PLANNING AND ZONING BOARD STAFF REPORT

Fifth Third Bank

Meeting	File No.	Application Type
November 17, 2025	PZ-000014-2025 (Level 4 Site Plan) PZ-000015-2025 (Waiver)	Level 4 Site Plan Modification, with Waiver
Property Owner	Authorized Agent	
1820 Federal Delray LLC	Nisit Sapparkhao, Infinity Engineering Group LLC

Provide a recommendation to the City Commission on a Level 4 Site Plan Modification, with Architectural Elevations and Landscape Plan, for Fifth Third Bank to demolish the existing building at 1820 South Federal Highway and to construct a one-story standalone branch bank with a drive-thru, with an associated waiver to reduce the minimum floor area from 6,000 square feet to 2,578 square feet pursuant to LDR Section 4.4.12(F)(2).

East Elevation

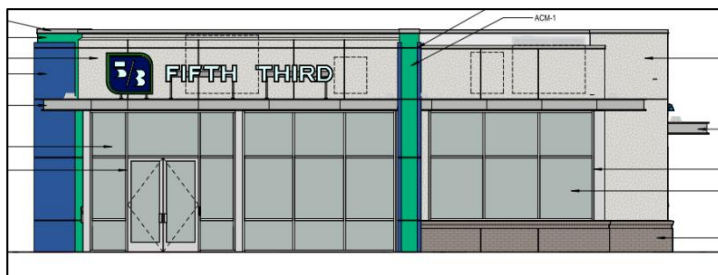
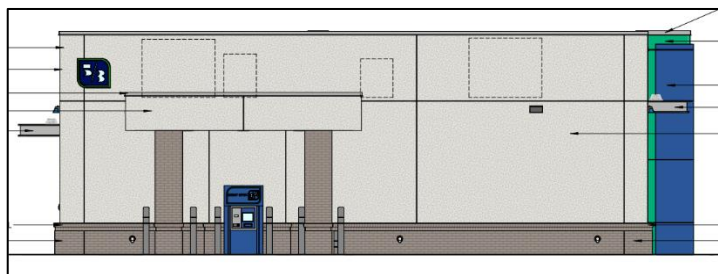
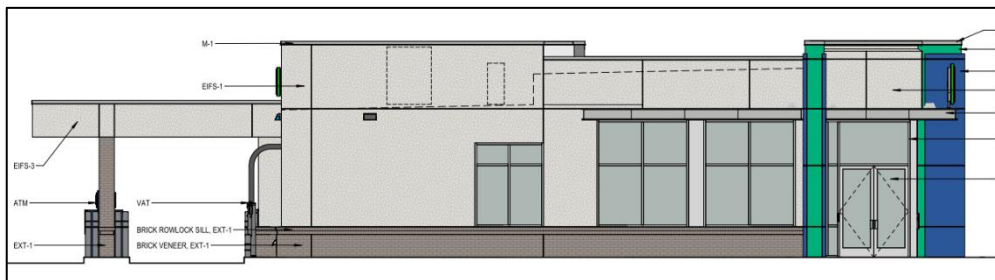
The height of the building includes a parapet that ranges from one foot to five feet and 11 inches to effectively screen the roof equipment. The parapet exceeds the maximum allowed height of 4 feet pursuant to LDR Table 4.3.4(J)(3) by one foot and 11 inches. The requested height exception for the parapet does not exceed the maximum allowed height of 48 feet within the PC zoning district, however. Pursuant to LDR Table 4.3.4(J)(3), parapets between four to 10 feet are an exception to the maximum height and the height exception requires board action by the approving body. The architectural elevations demonstrate the necessity of the parapet for screening purposes and its integration into the overall building design. A justification statement has been provided by the applicant addressing compliance with the criteria of Section 4.6.18(E). The Board must determine whether the height exception maintains the intent of the regulation, preserves the visual quality of the surrounding area, and does not result in adverse impacts on the local environment.
